GRIFFIN NOVI JSP 20-27

Public hearing at the request of Singh Development, LLC for JSP 20-27 Griffin Novi for Planning Commission's recommendation to the City Council for approval of a Preliminary Site Plan with a PD-2 Option, Special Land Use permit, Wetland Permit, and Stormwater Management Plan approval. The subject property is located at the southeast corner of Twelve Mile Road and Twelve Oaks Mall access drive in Section 14. The applicant proposes to utilize the Planned Development 2 (PD-2) option to develop 174 multi-family residential units. A private street network is proposed to connect the development to Twelve Mile Road and the Twelve Oaks Mall access drive on the west side of the property.

PLAN REVIEW CENTER REPORT

January 25, 2022 Planning Review Griffin Novi

Photo 1: Overview of the Site, facing northwest (May 3, 2021).

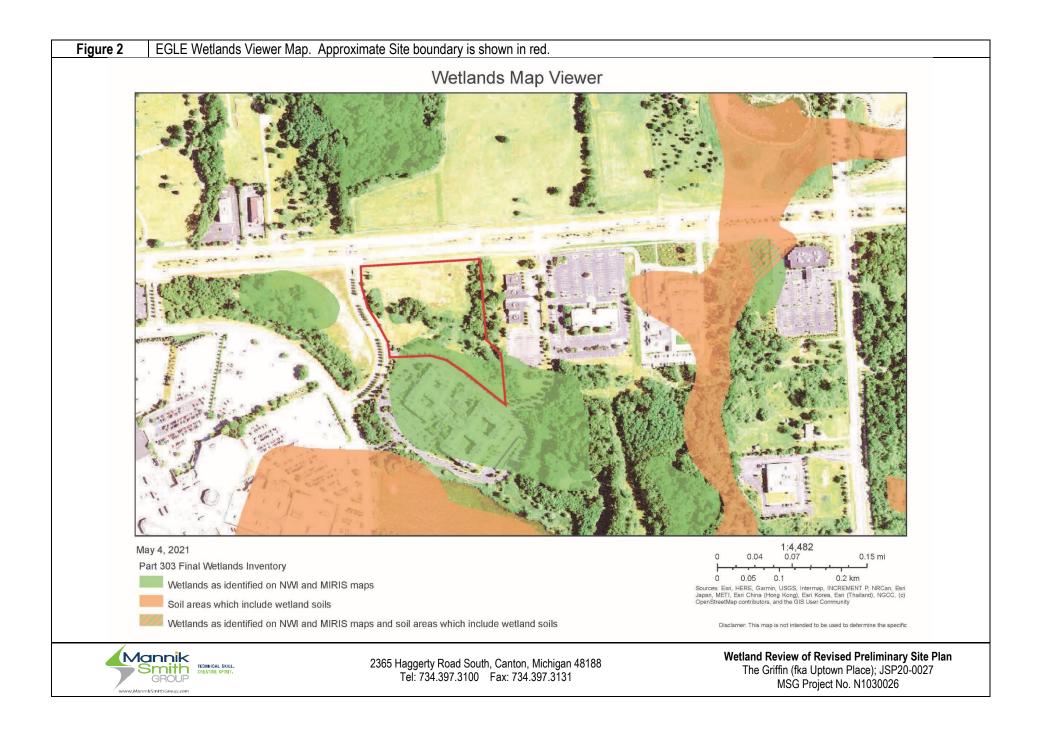
It is MSG's opinion additional information regarding the limits of Wetland A is necessary. MSG observed a swale to the east of the southern end of Wetland A that included evidence of wetland hydrology and wetland vegetation at the (Photo 3, Photo 4, and Figure 3). It is unclear to MSG why this area was not included in the limits of Wetland A.

MSG reviewed the Response to Comments for Uptown Place Development letter prepared by Wilson Road Group (WRG) dated July 31, 2021. MSG notes WRG expanded the limits of Wetland A as suggested by MSG. The revised size of Wetland A was identified by WRG to be 0.206 acre, bringing the combined acreage for Wetlands A and B to 0.241 acres, which is below the City's 0.25-acre threshold for compensatory mitigation. The revised wetland acreage is depicted on Sheet PSP8 of the rPSP. MSG observed the square footage of Wetland A noted on Sheet PSP8 was not similarly adjusted however, and suggests this typo be corrected.
